2.15 Structures and Servicing Systems

The information in this section of the reference ABWR DCD, including all subsections, tables, and figures, [as modified by the STP Nuclear Operating Company Application to Amend the Design Certification rule for the U.S. Advanced Boiling Water Reactor \(ABWR\). "ABWR STP Aircraft Impact Assessment \(AIA\) Amendment Revision 3." dated September 23, 2010](#) is incorporated by reference with the following departures.

STD DEP T1 2.14-1 (Figure 2.15.10a, Figure 2.15.10j, Figure 2.15.5e, Table 2.15.5c)

STD DEP T1 3.4-1 (Figure 2.15.12a, Figure 2.15.12b, Figure 2.15.12g)

Table 2.15.5c Reactor Building Safety-Related Equipment HVAC System

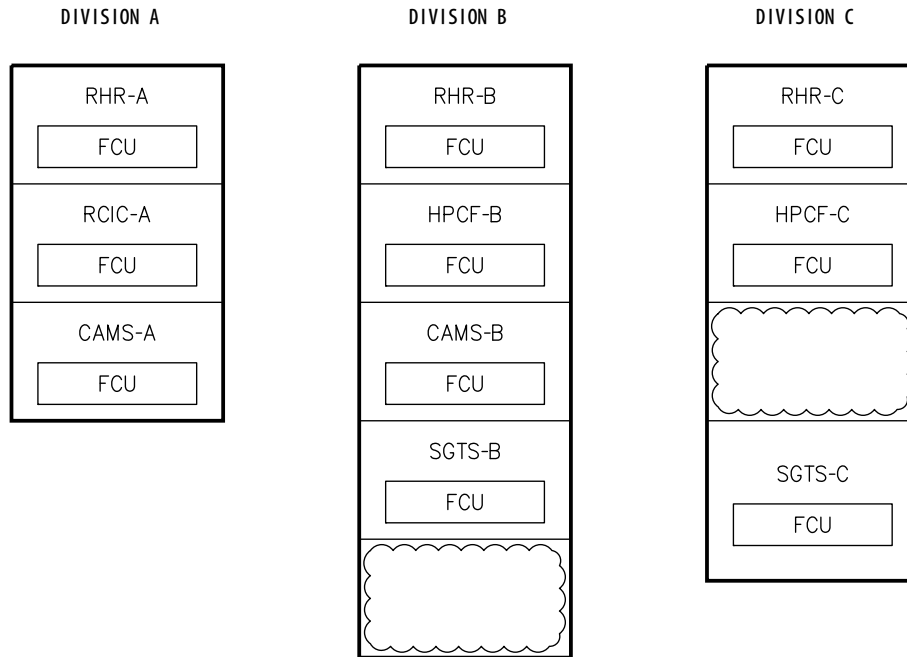
The Residual Heat Removal (RHR) System, High Pressure Core Flooder (HPCF) System and Reactor Core Isolation Cooling (RCIC) System pump room FCUs are automatically initiated upon startup of their respective room process pump. The Containment Atmospheric Monitoring System (CAMS) and Standby Gas Treatment System (SGTS) room FCUs are automatically initiated upon isolation of the Reactor Building Secondary Containment HVAC System. ~~The Flammability Control System (FCS) room FCUs are also initiated upon a manual FCS start signal.~~

Inspections, Tests, Analyses and Acceptance Criteria		
Design Commitment	Inspections, Tests, Analyses	Acceptance Criteria
4. The FCS room FCUs are initiated upon a manual FCS start signal. Not used.	4. Tests will be conducted on each as built FCS room FCU using a simulated initiation signal. Not used.	4. The FCS room FCU starts upon receipt of a signal indicating FCS start. Not used.

Figure 2.15.5e Reactor Building Safety-Related Equipment HVAC System

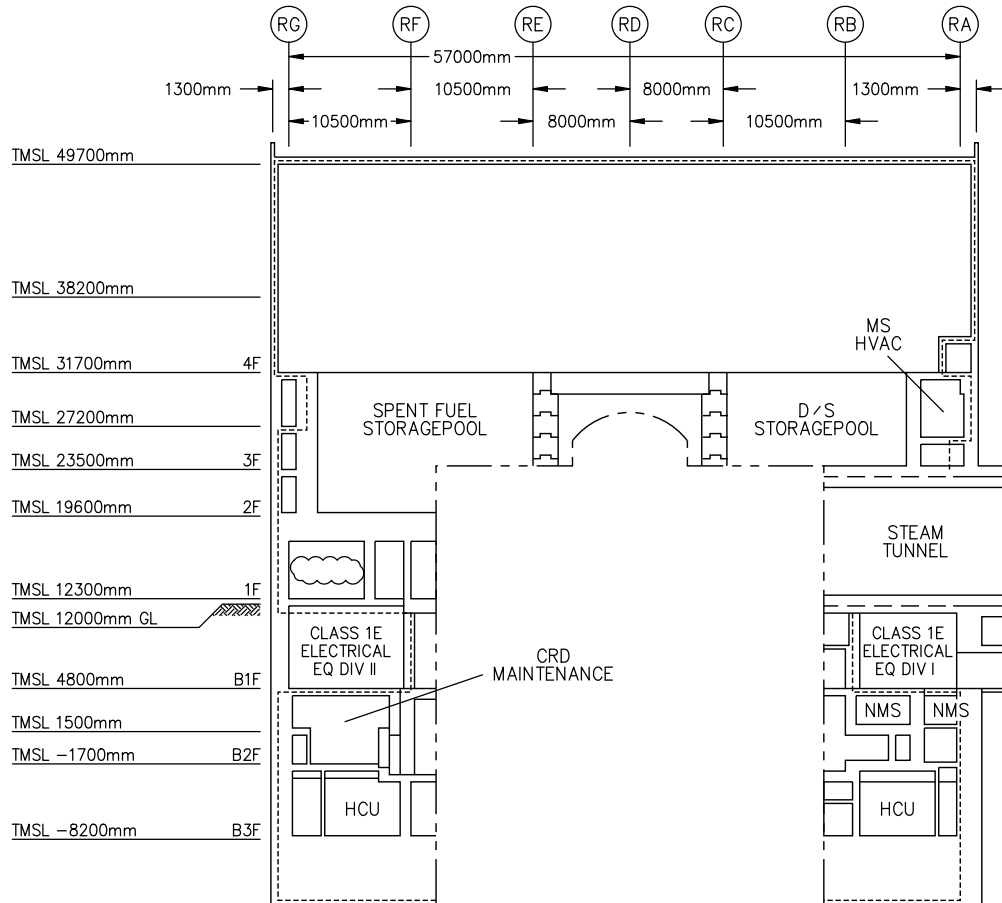
The R/B Safety-Related Equipment HVAC System provides cooling of safety-related equipment areas, and consists of independent fan coil units. Figure 2.15.5e shows the basic system configuration and scope.
